DRB RECOMMENDATION

## 121 15th Ave E. Seattle, WA

SDCI PROJECT NO.:  
3020958

MEETING DATE:  
07.20.2016

## DEPARTURE #1-2

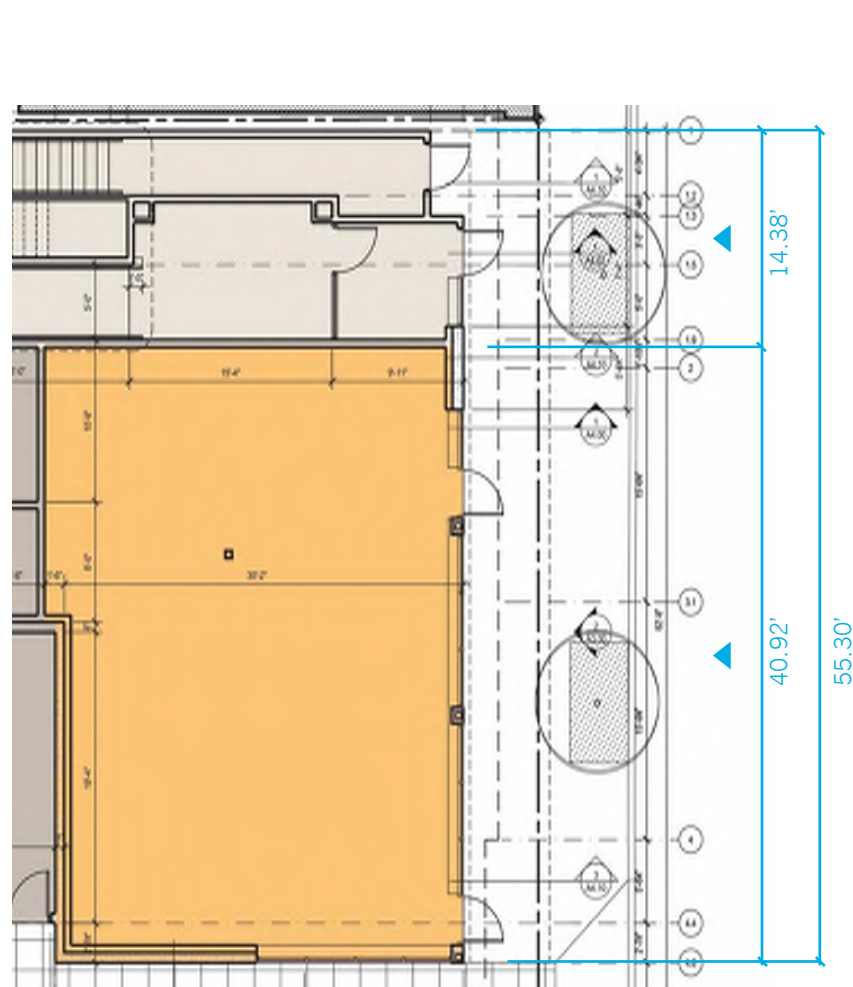
Per SMC 23.47A.008 C1 – A minimum of 80 percent of the width of a structure’s street-level street-facing façade that faces a principal pedestrian street shall be occupied by uses listed in subsection 23.47A.005.D.1. The remaining 20% of the street frontage may contain other permitted uses and/or pedestrian entrances.

From EDG response, “The Board indicated preliminary support for the departure, provided the entry is well proportioned and detailed, as the entry aligns with open spaces in the surrounding area. (Guideline CS2-B2)”

We request a departure to allow for required residential egress. 14.38’ is required for residential egress, approximately 26% of the proposed 55.30’ street-facing façade. The secondary residential egress to the North is also recessed 5’ to help influence the permitted use on the street-level as more dominant.

TOTAL GROUND FLOOR WIDTH: 55.30

COMMERCIAL WIDTH: 40.92’ (74%)

RESIDENTIAL WIDTH: 14.38’ (26%)
